**Banyule City Council, Boroondara City  
Council, Manningham City Council,  
Whitehorse City Council**

**North East Link EES**

**Review of Matters Relating to Surface Water**

**July 2019**

Figure 4-12 Extract of Figure 9-13 from Surface Water Technical Report not indicating any drainage or WSUD features immediately north or south of Lower Plenty Rd

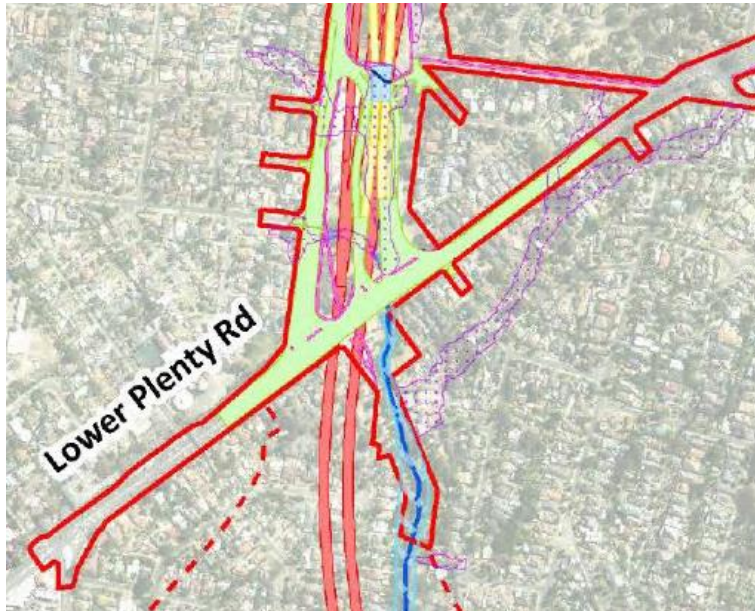
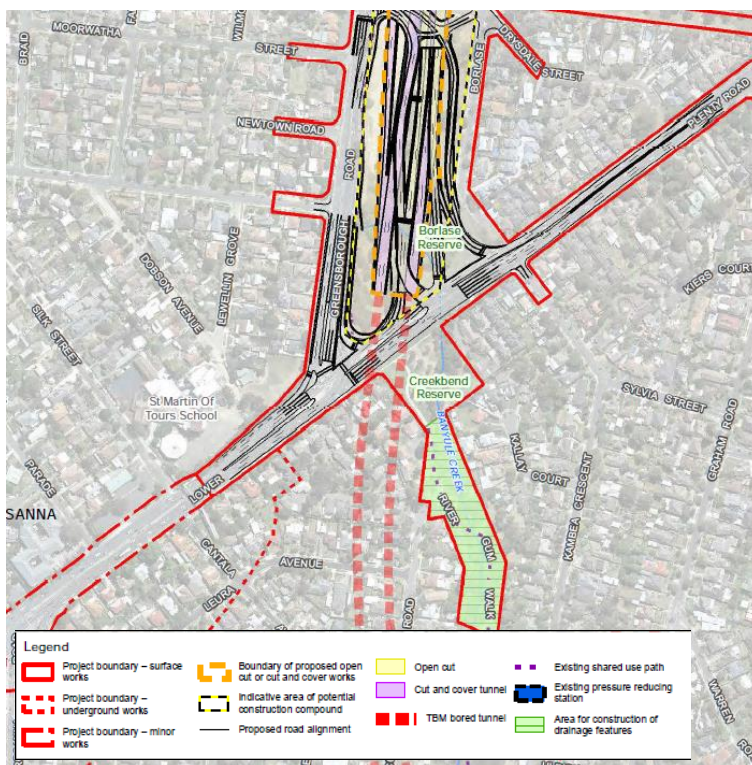
Since the issue of the initial draft of the Surface Water Technical Report in July 2018 it has been understood that a new flood retarding basin is likely to be constructed immediately north of Lower Plenty Road to ensure that flooding downstream of Lower Plenty Road is not adversely impacted by the Project. Nothing is noted on the layout plan contained within the Surface Water Technical Report, as shown in Figure 4-12 below, with respect to a flood storage or water quality feature. The layout plans have depicted flood

storage locations elsewhere within the Project area (Compensatory Flood Storage Locations). Figure 4-13 identifies an area south of Lower Plenty Road where drainage features are proposed. It is not clear from the EES documents what function these drainage features are expected to perform.

Figure 4-14 Figure F-2 from Appendix F of Surface Water Technical Report

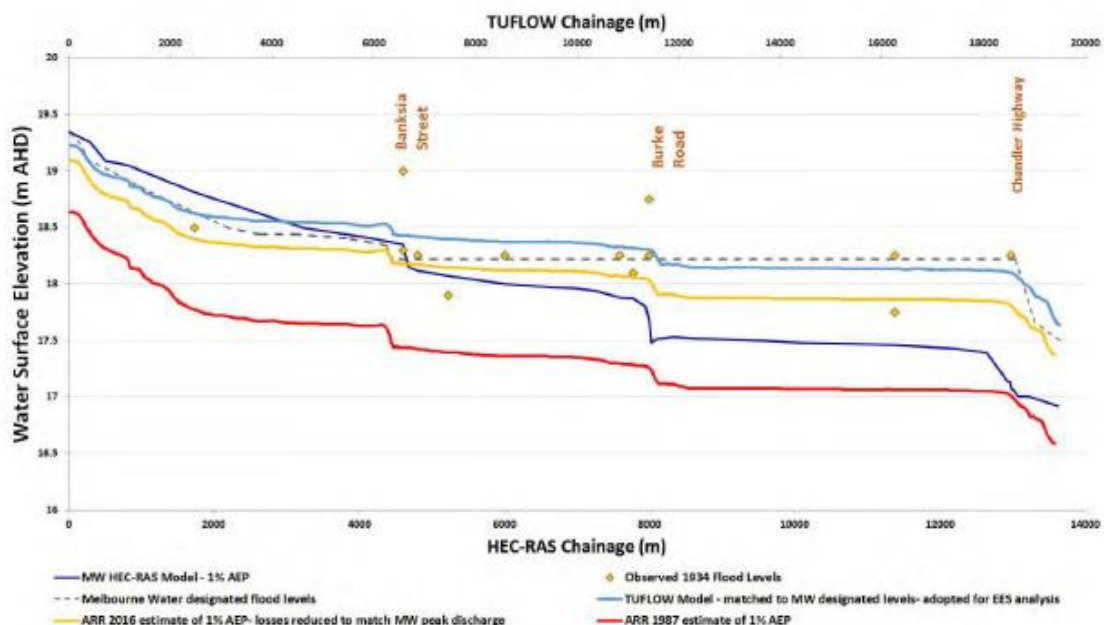
With respect to the modelling of the Yarra River catchment I agree that there are some uncertainties with respect to use of 1934 flood levels for designating the 1% AEP flood levels. This is due to the nature of change within the catchment over time including the construction of dams and retarding basin within the catchment to manage flooding. Figure F-2 in Appendix F of the Surface Water Technical Report, reproduced as Figure 4-14 below, presents the water levels from a sensitivity analysis of Yarra River flood flow estimates produced from a range of methodologies. Figure F-2 highlights the uncertainty associated with the Yarra River flood flow estimates as the upper and lower flood flows correspond to a difference in water levels in some locations of greater than 1 metre.

Figure 4-19 Existing conditions flooding at Douglas Street

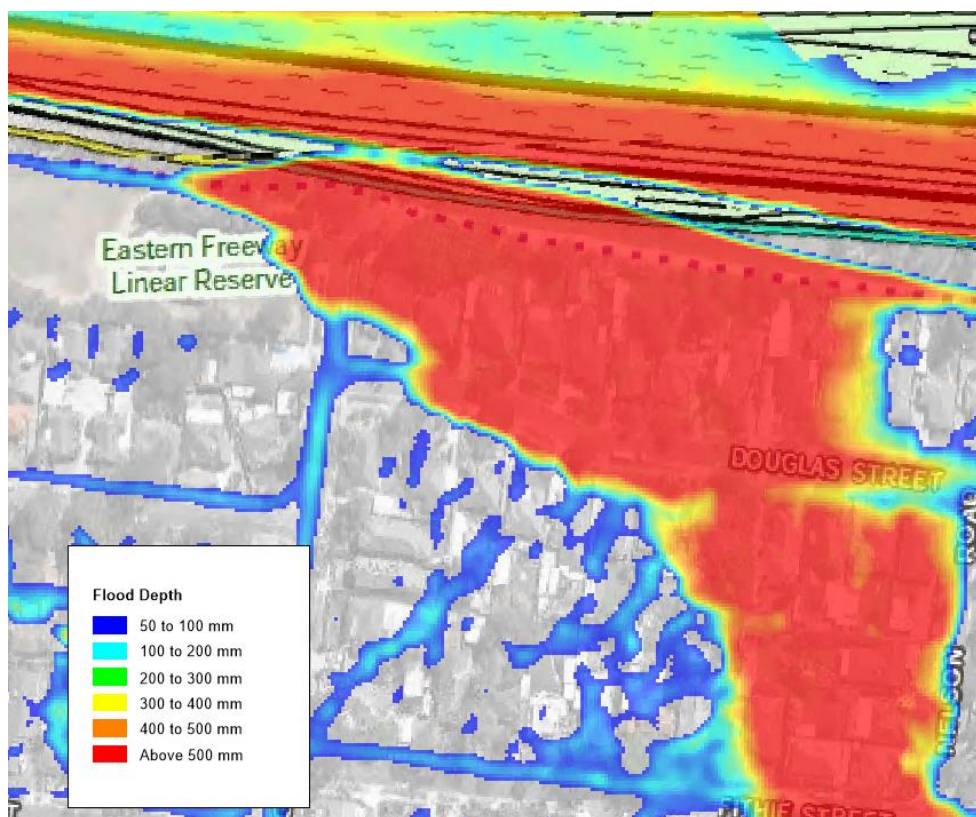
As stated in Section 4.1 the flooding assessment has also not assessed all likely flooding impacts associated with the Project since the existing conditions modelling has not considered all flood prone areas within the Project area. An example of a location that has not been identified as having any flooding impacts associated with the project is at Douglas Street, Blackburn North. As shown in Figure 4-19 below the Project will expand the Eastern Freeway southwards and as result the works, including a new noise wall, will be constructed within the extent of a predicted flood prone area. There are several other locations across the Project area like this whereby the impacts have not been assessed.

Figure 5-7 Existing ground surface profile (yellow line)

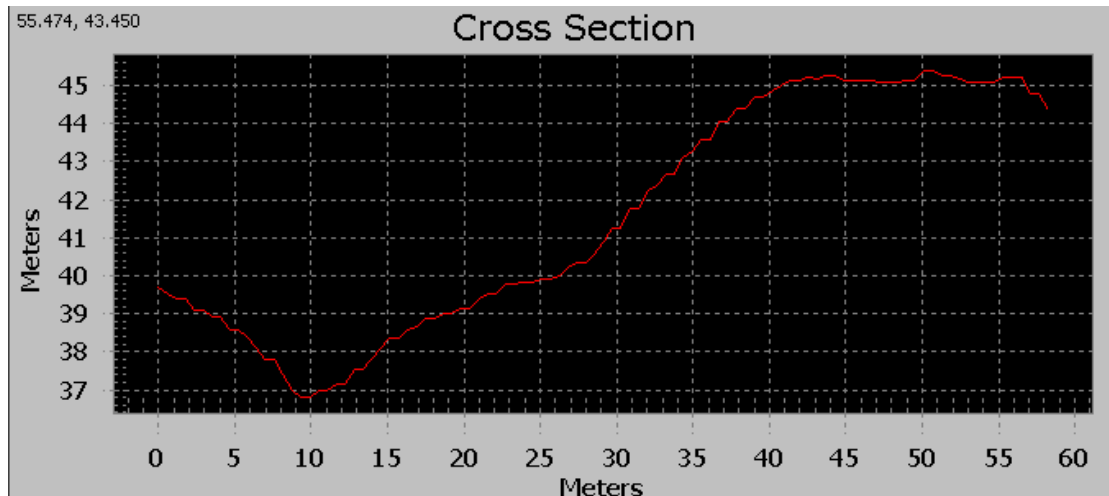
I have assessed the existing landform at the area where WSUD ID 7 is proposed and identified a significant constraint to its implementation in the form of the existing ground surface profile. I have examined two cross sections through the existing ground surface profile at the locations identified by the purple and yellow arrows in Figure 5-6 below. Figures 5-7 and 5-8 show the existing ground surface for these locations and highlight the significant variance in existing ground surface levels in this area. Based on consideration of the existing terrain and the proposed design it is difficult to envisage how a wetland would be constructed at this location without a significant retaining structure. Furthermore, it is unclear if the location of this proposed asset is a factor in the reference design proposing to divert sections of Koonung Creek. If it is, I believe this is unacceptable and the asset is recommended to be relocated to a more appropriate location to reduce the environmental impact.

I believe that the functionality and siting of proposed water quality treatment assets needs to be considered as part of the EES assessment. In the absence of a proof of concept it is possible that alternative locations for implementation of mitigation measures within open space / parklands areas will be required and could result in other / greater environmental impacts not identified in the EES.
